# **A d d e n d u m**

Iowa Department of Transportation  
Office of Contracts

<b>B.O.</b>	<b>Proposal ID</b>	<b>Proposal Work Type</b>	<b>County</b>	<b>Project Number</b>	<b>Addendum</b>
020	94-C094-104	Bridge Replacement-PPCB	Webster	FM-C094(104)--55-94	21FEB020A01

PROJECT NO. FM-C094(104)--55-94  
BRIDGE REPLACEMENT - PPCB  
210TH ST./15TH AVE. S. OVER GYPSUM CREEK

SHEET 1 OF 37

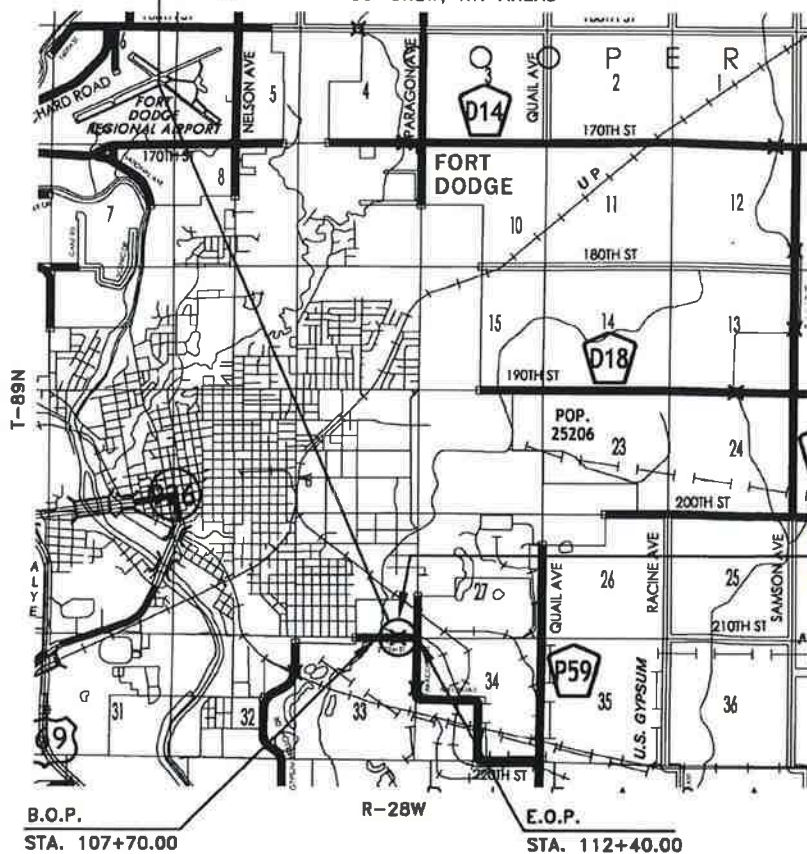
Sheet 1 of 37 (see attached):

ADD Union Pacific Crossing  
D.O.T. Crossing #200941X

The actual crossing location is just north of the "T" intersection east of the bridge project.

UNION PACIFIC CROSSING  
D.O.T. CROSSING NO. 200941X
